# Work Order ID 87898

Item ID: D3695-041 Accept **\*N900040100\*** Setup Start **\*NS1\***  
 Revision ID: Stop **\*NS2\***  
 Item Name: Slider Assembly  
 Start Date: 7/17/2012 Start Qty: 4.00 **\*4\*** Cust Item ID:  
 Required Date: 7/27/2012 Req'd Qty: 4.00 **\*4\*** Customer:  
 Reference:

### D3695-041 SLIDER ASSEMBLY

DRAWING NO. D3695  
REV. E  
SHEET 1 OF 3  
TITLE SLIDER ASSEMBLY  
SCALE NTS

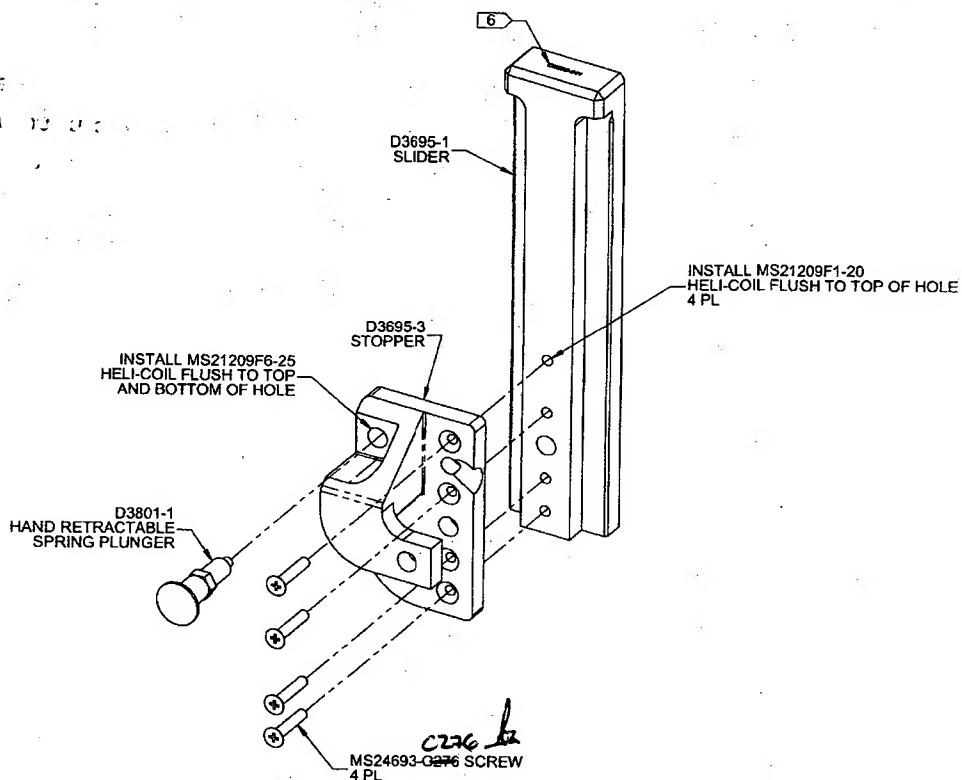
Root Cause	Date	Step	Qty	Description of work order update or Non-conformance	Initial Chief Eng	Action Description	Sign & Date	Verification	QC Inspector
Doc/Data <input type="checkbox"/> Equip/Tooling <input type="checkbox"/> Operator <input type="checkbox"/> Material <input type="checkbox"/> Setup <input type="checkbox"/> Other <input checked="" type="checkbox"/> Process <input type="checkbox"/> Supplier <input type="checkbox"/> Training <input type="checkbox"/> Unapproved <input type="checkbox"/>	12/07/25	100	4	MS24693-C276 TOO LONG - BOTTOM HOLE OUT, REASON: CSINK TOO DEEP IN SAME PARTS.	12/07/25	INSTALL USWA MS24693-C274.  MS24693-C274 B/W: <u>M113928</u>	 12/07/25
